Submissions Report

Modification to the Picton Regional Sewerage
Scheme

November 2012

Figure 2 (updated) – Existing Scheme Boundary and Phase 1 connection areas (as approved by previous modification)

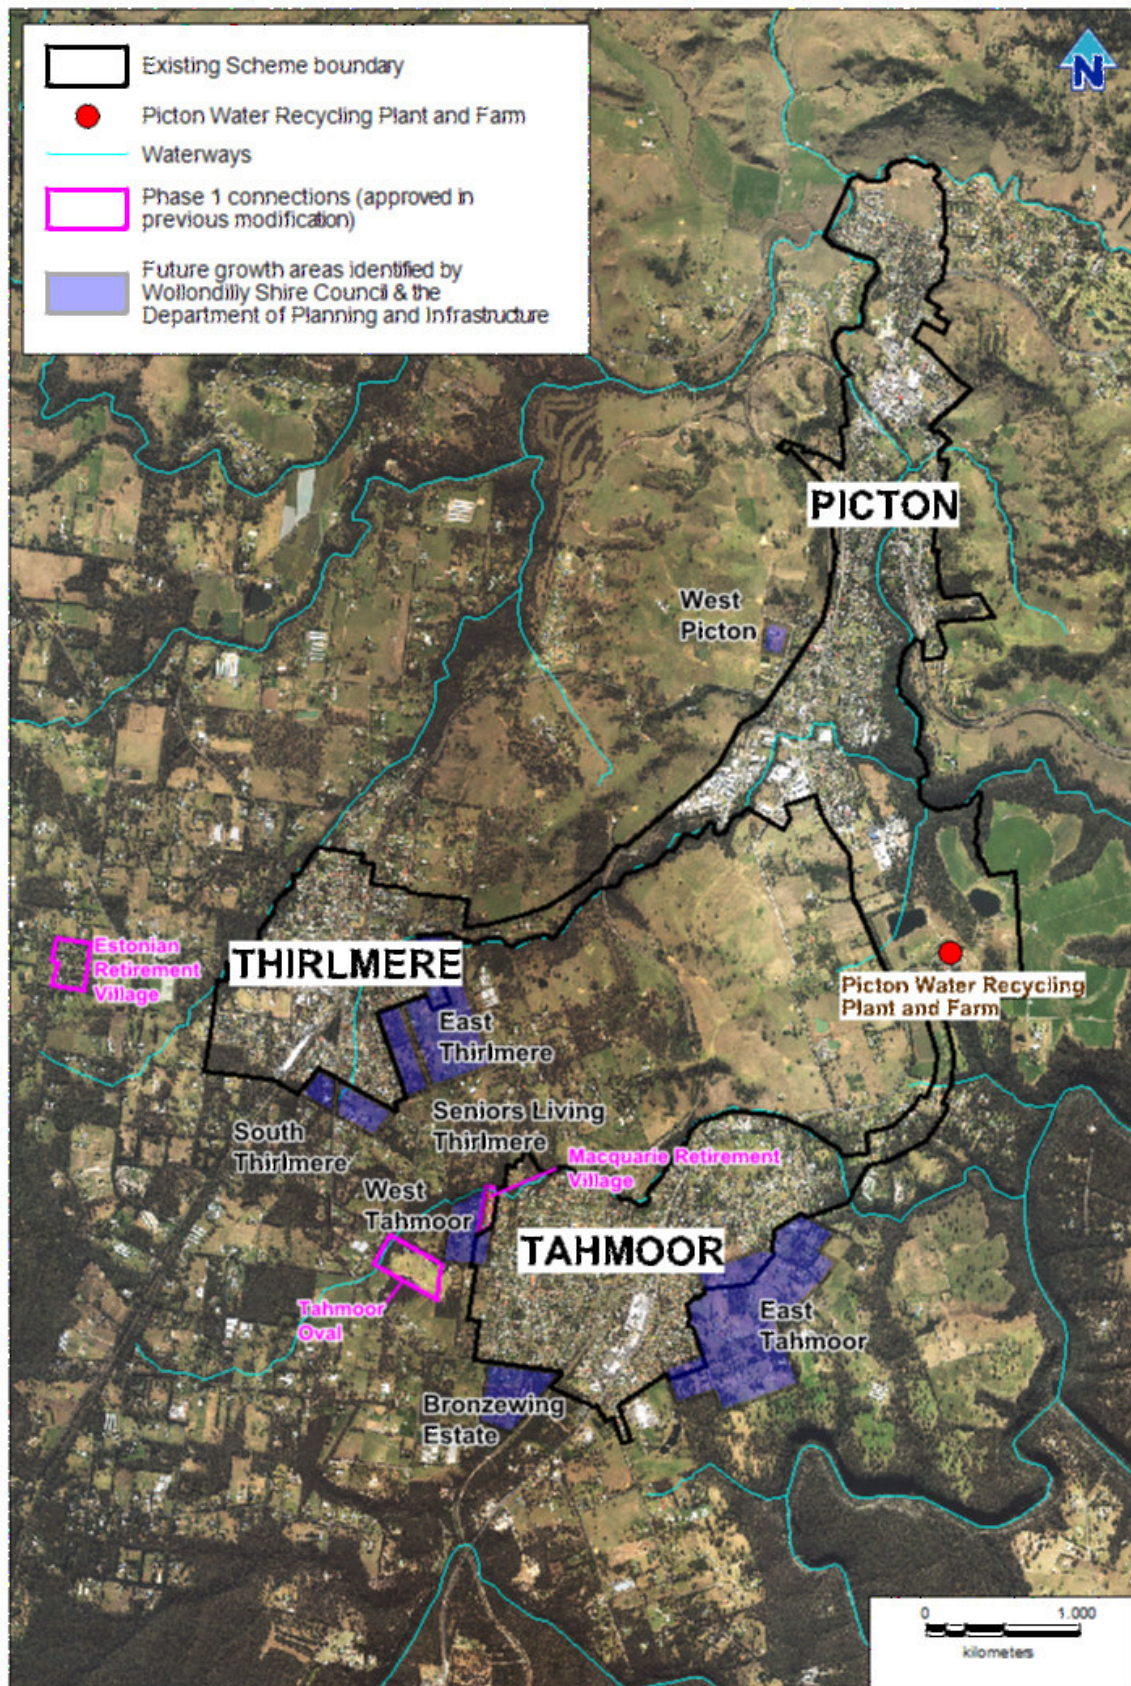
Council notes the Growth Areas mapped in Figures 2, 3, 4 and 5 to the Assessment Report prepared by Sydney Water and submitted with the application require correction. The correct "growth areas" are shown in Attachments to this letter. Council has advised Sydney Water direct of the need for these corrections

The Growth Areas mapped in Figures 2, 3, 4 and 5 of the Assessment Report were based on the NSW Department of Planning's 2008-09 Metropolitan Development Program (MDP) Report (DoP, 2010).

Sydney Water has reviewed the more recent information provided by Wollondilly Council and updated the figures from the Assessment Report accordingly. Figure 2 shows the current Scheme, including existing boundary and Phase 1 connections) and Figures 3, 4 & 5 show the proposed modified Scheme, including no boundary and indicative new growth areas provided by Council.
